DECISION OF THE PLANNING ADMINISTRATOR

CLASS 3 SITE PLAN REVIEW CASE NO.: SPR25-08

IN THE MATTER OF APPROVAL OF)	FINDINGS & ORDER
CLASS 3 SITE PLAN REVIEW)	
CASE NO. SPR25-08)	
1317 STATE ST)	April 21, 2025

Summary: A building addition and parking lot reconfiguration for an existing *retail sales* use.

1 PROPOSED STATE STREET ELEVATION- SOUTH
1/4" = 1'-0"

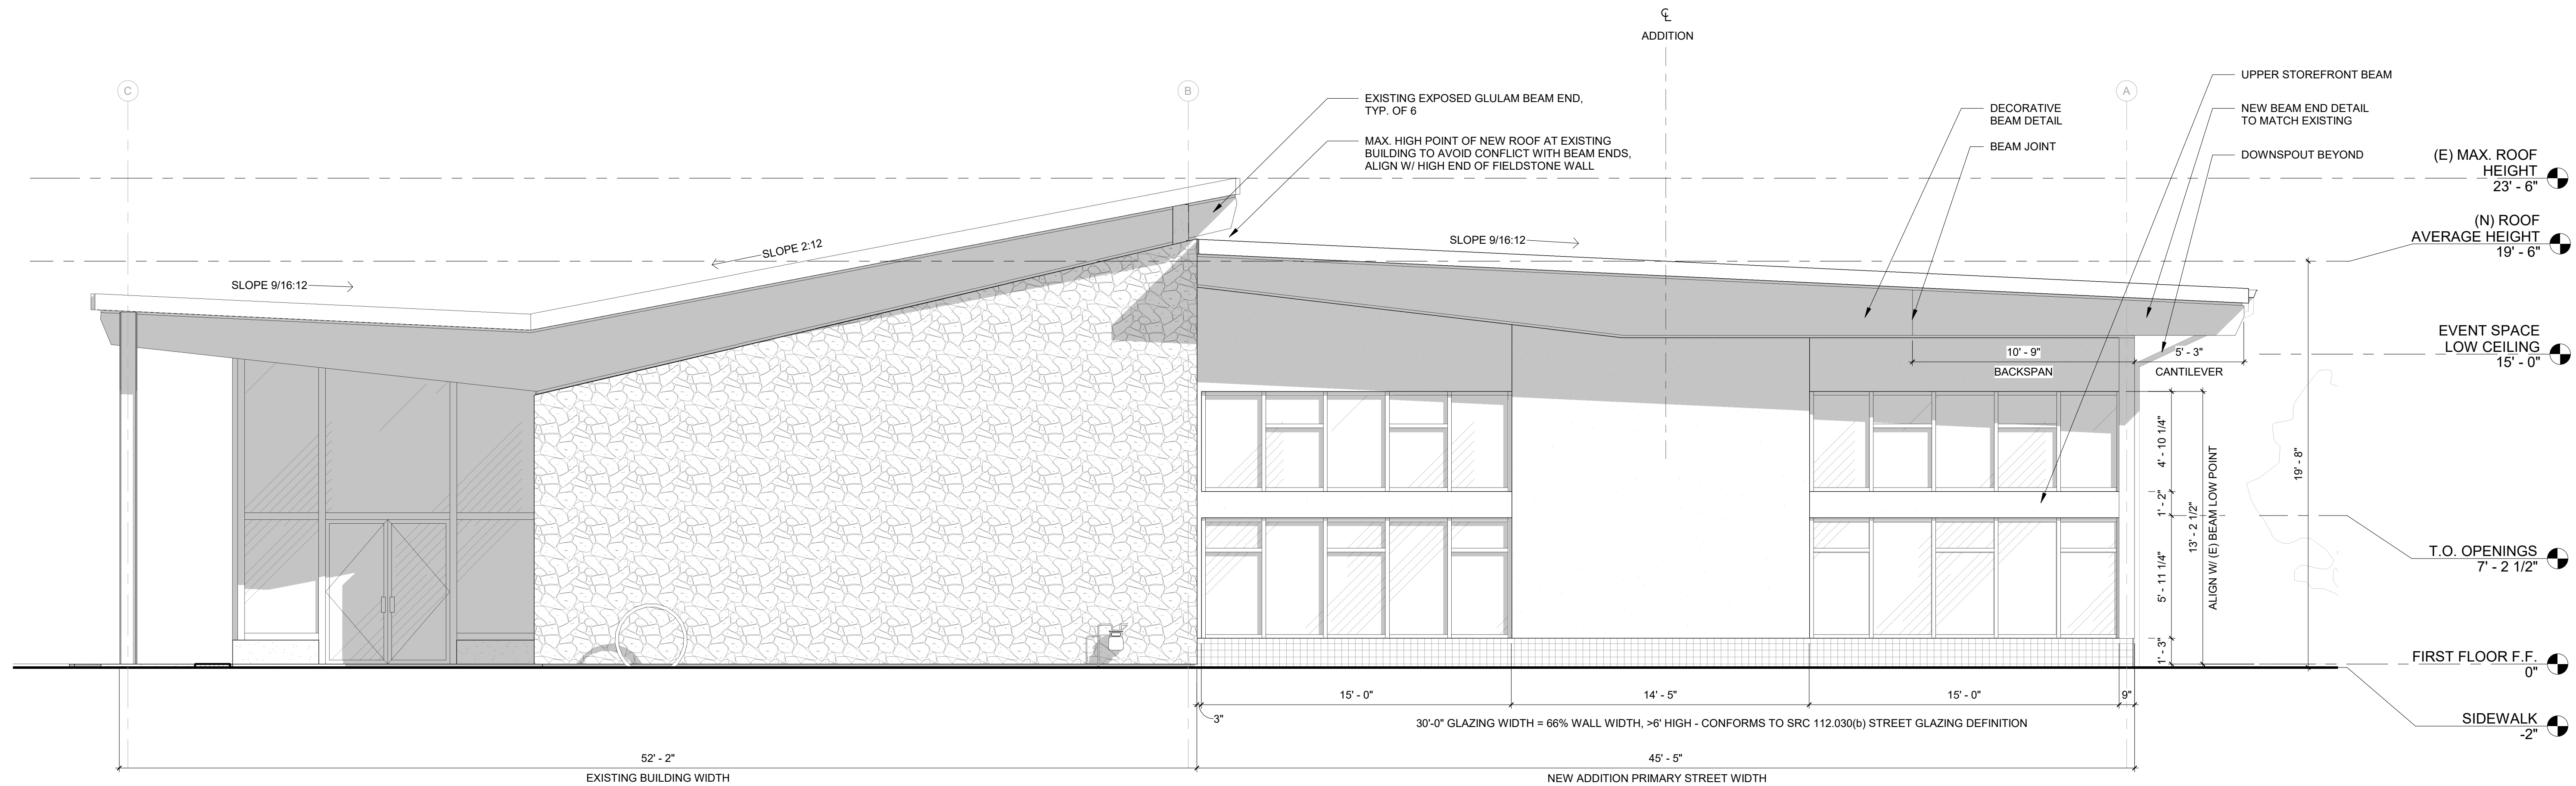
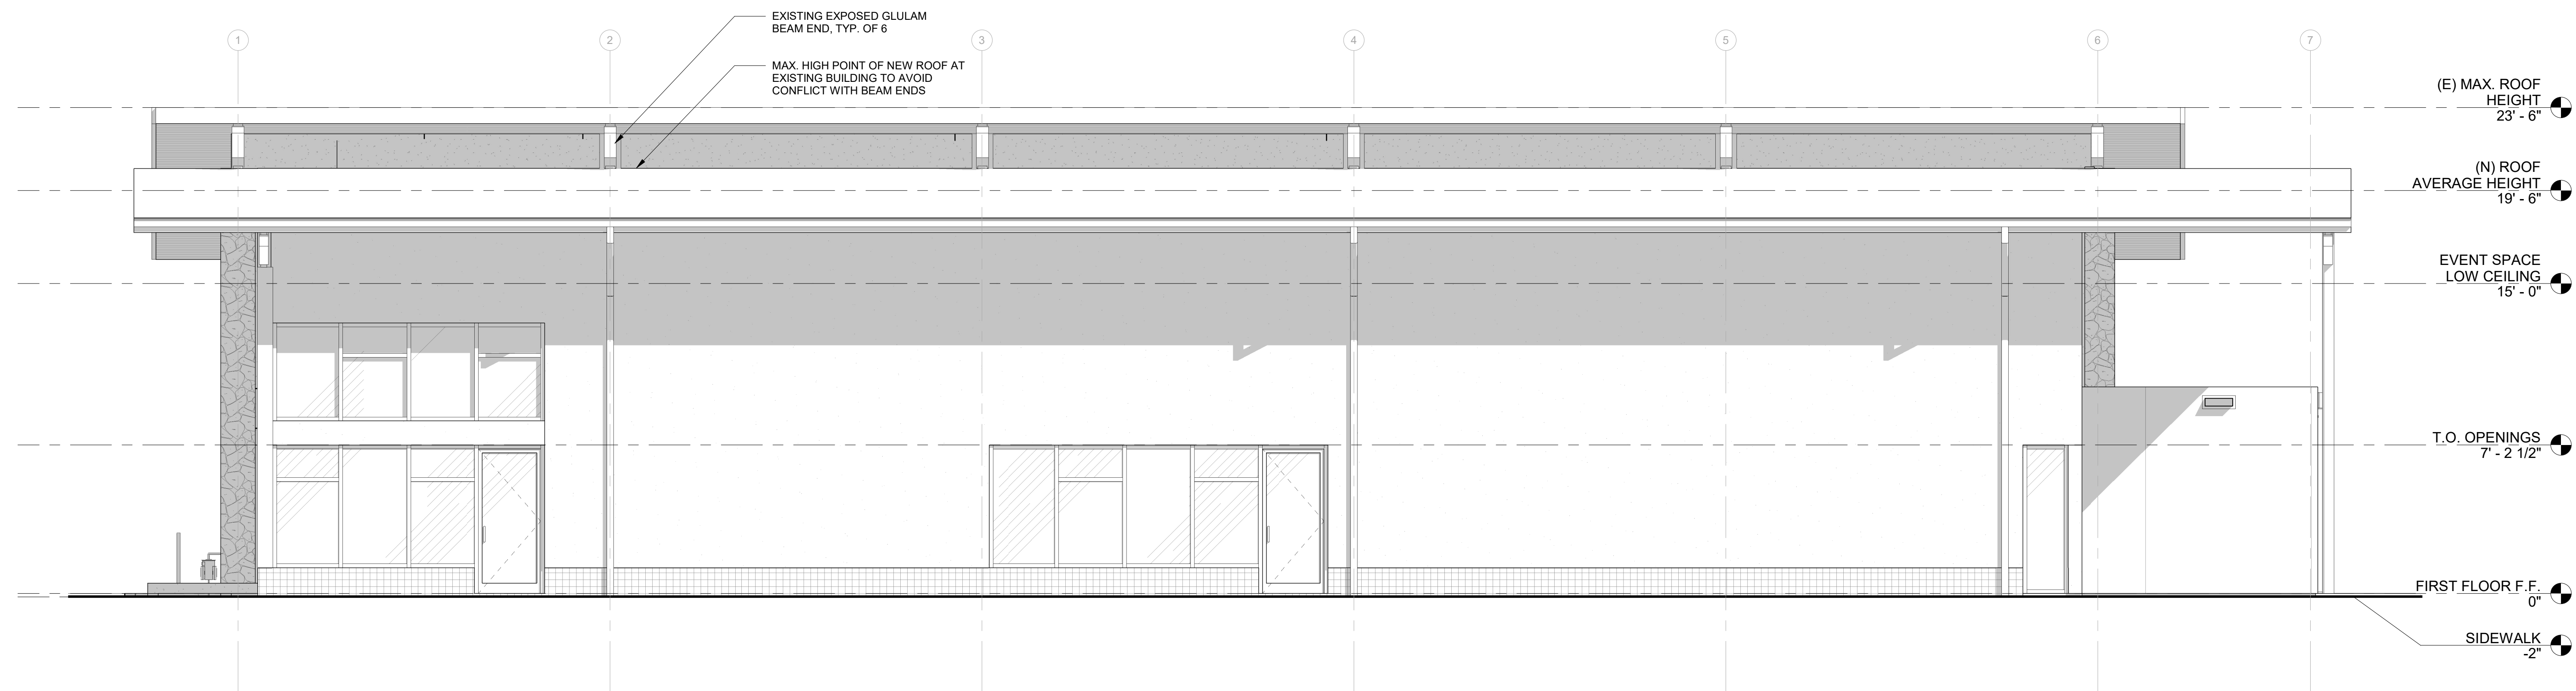
Finding: The façade of the existing building has approximately 54 feet of frontage on State Street, and the proposed addition will add approximately 45 feet of frontage on State Street, effectively increasing the building façade by 85 percent. Therefore, as the addition enlarges an existing building façade area facing a primary street by more than 60 percent, the development shall meet all applicable development standards per SRC 533.015(g)(2)(F).

Finding: The applicant's plans show the height of the event space ceiling of the addition to be 14 feet tall, meeting the standard.

Finding: A minimum of 65 percent of the ground floor building façade is required to be windows. Per SRC 112.030(b), as the windows are at least six feet in height, the percentage of ground floor windows can be calculated by dividing the total width of windows along the ground floor of the building by the length of the ground floor of the building. Approximately 32 feet of the 45-foot five-inch façade is windows, meeting the standard.

Finding: The applicant's plans show that at least 75 percent of the building addition will have awnings at least eight feet above the ground and six feet deep, meeting the standard.

1 PROPOSED SITE PLAN
3/32" = 1'-0"

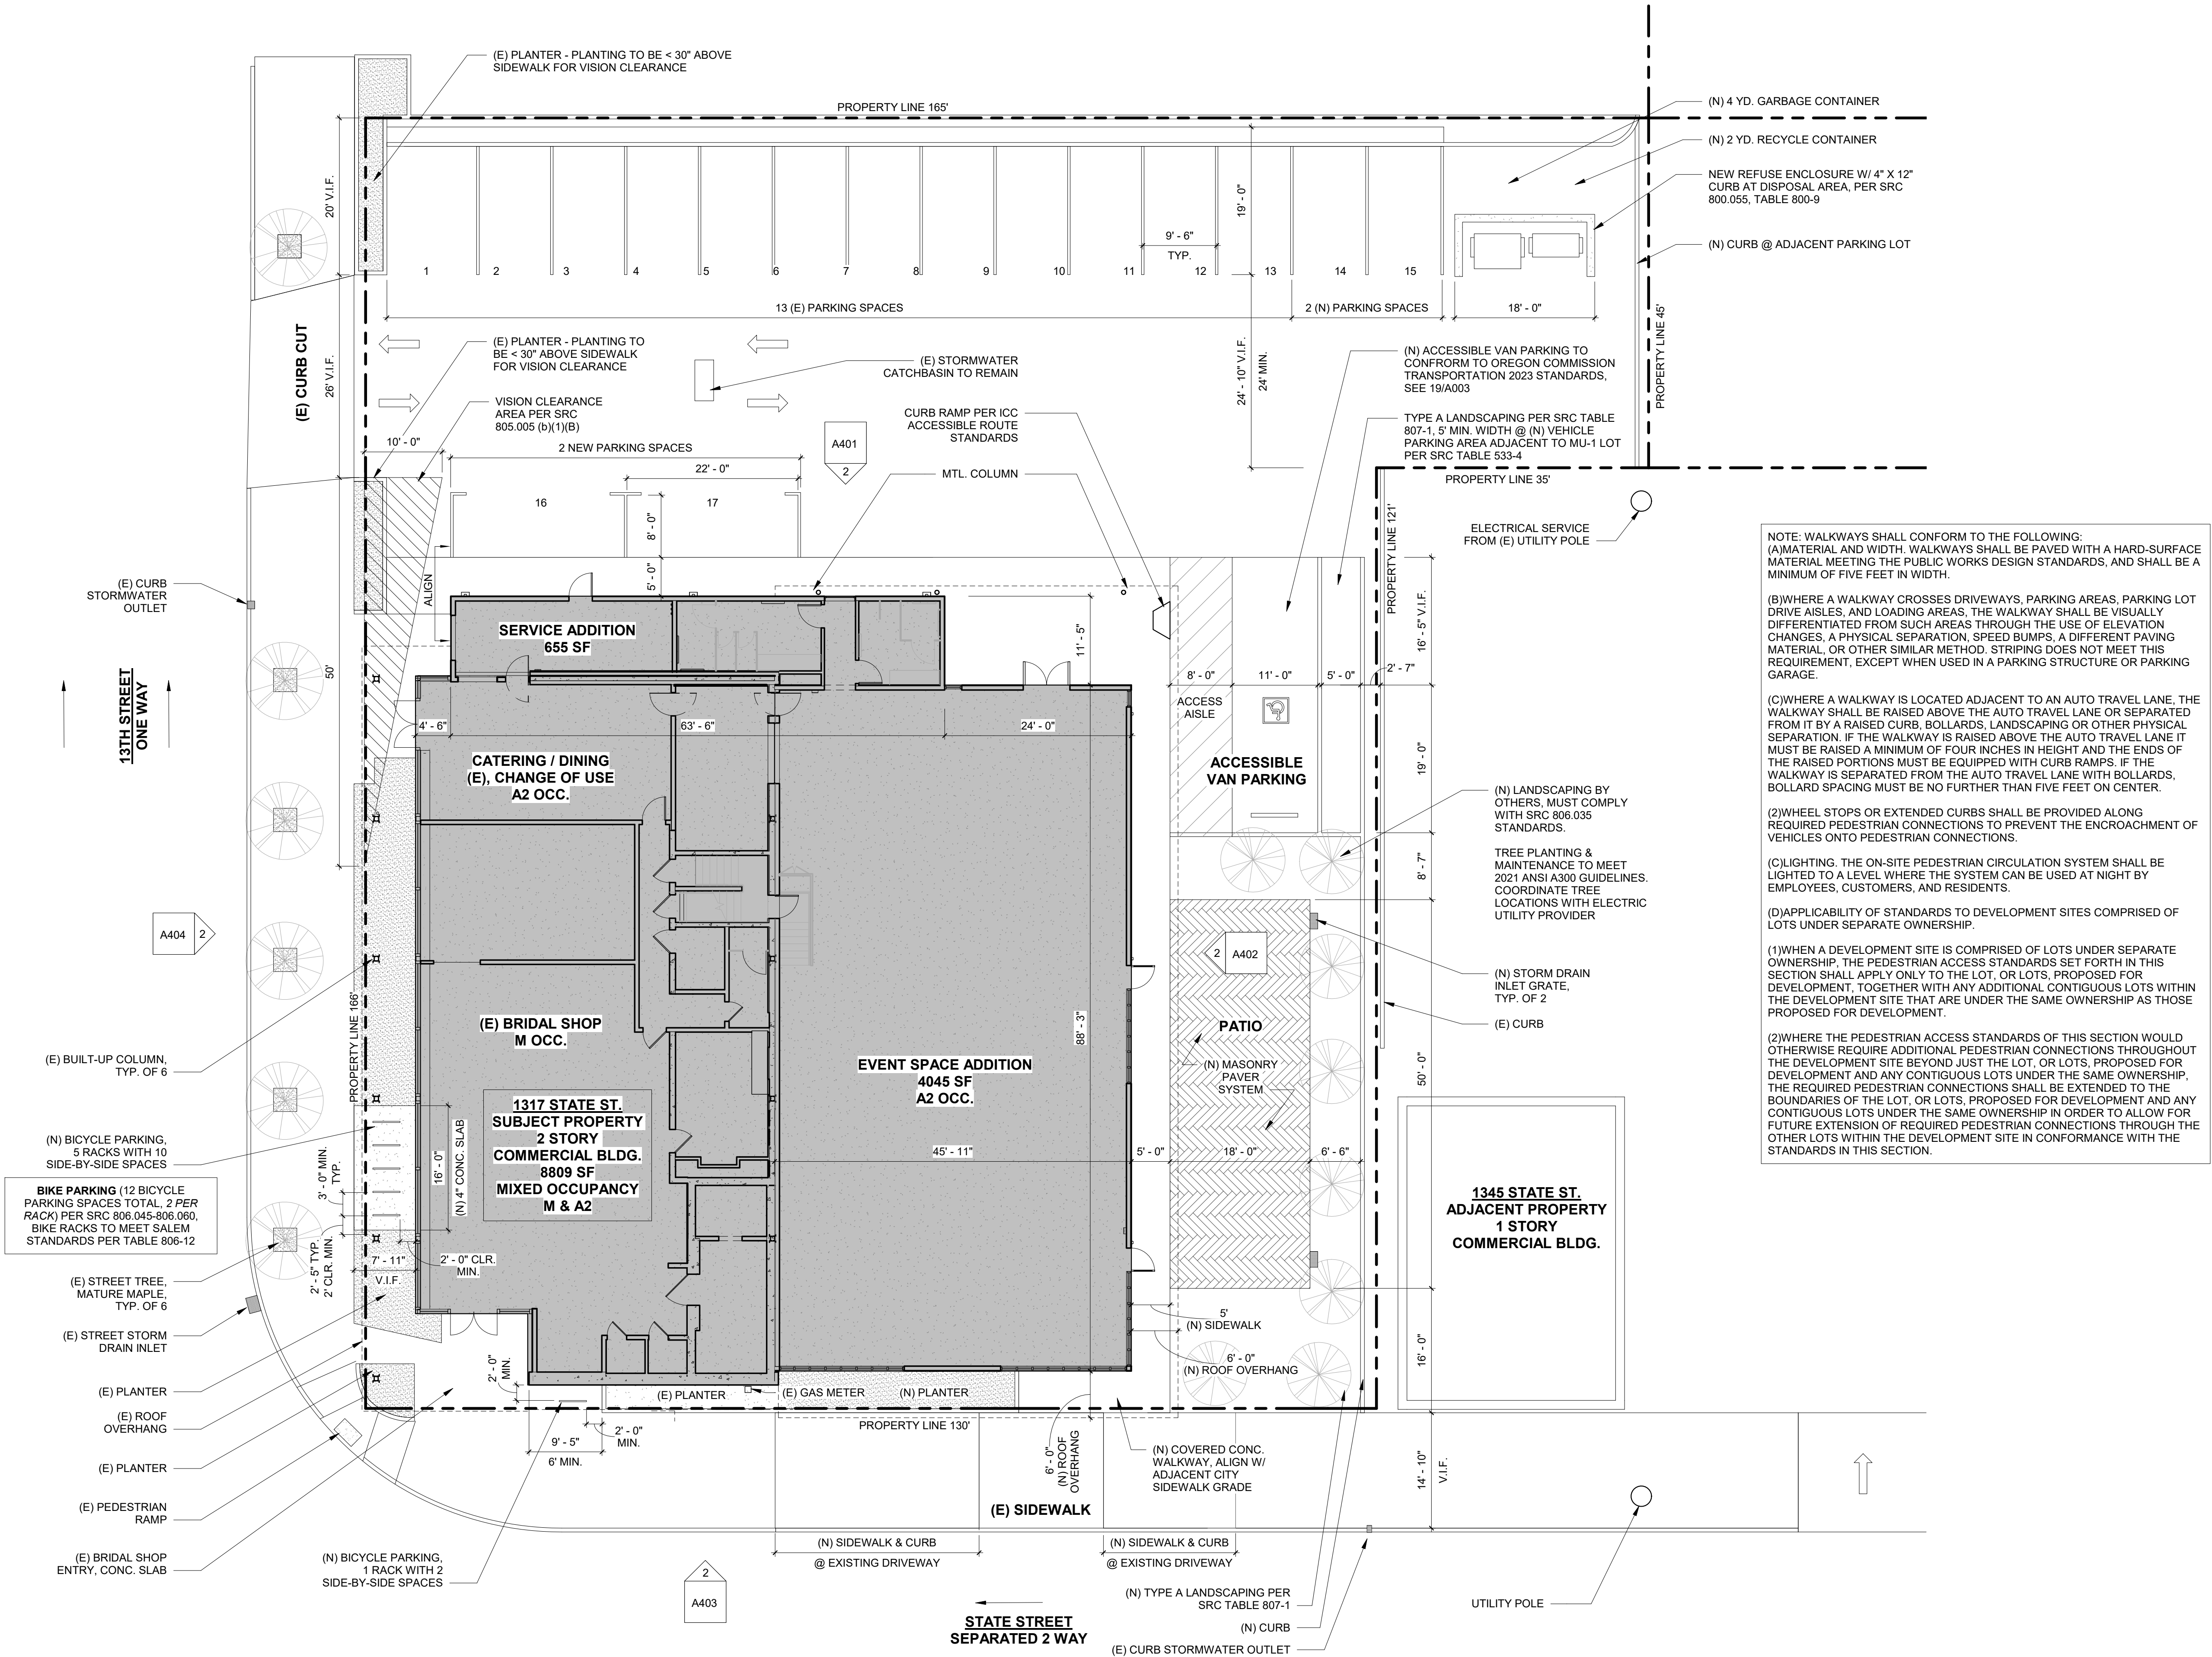
The proposed vehicle use area abutting the eastern property line is shown not meeting the minimum five-foot vehicle use area setback. Therefore, the following Condition applies:

Finding: The applicant is proposing a new solid waste service area located on the northeast part of the property within the off-street parking area. Preliminary plans have been provided for the solid waste service area; therefore, the following Condition applies:

property. As no pedestrian connection is proposed to connect the properties, the following Condition applies:

There are two existing driveway approaches onto State Street that serve the existing development site. The applicant's plans show a new building where these driveway approaches are located. Per SRC 804.035(c)(1) driveway approaches are only permitted onto arterial roadways which serve permitted vehicle use areas. Upon construction of the building, the driveway approaches will no longer serve a vehicle use area. As such, they are required to be permanently closed and replaced with curb and sidewalk as a condition of approval.

Condition 2: Prior to issuance of building permits, the modified vehicle use area shall have a minimum five-foot setback per Table 533-4 and landscaped to a Type A standard per SRC Chapter 807.

Condition 3: At building permit review, provide detailed plans of the solid waste service area meeting the applicable standards of SRC 800.055.

Condition 5: As shown on the applicant's plans, permanently close the unused driveway approaches onto State Street and replace with curb and sidewalk.
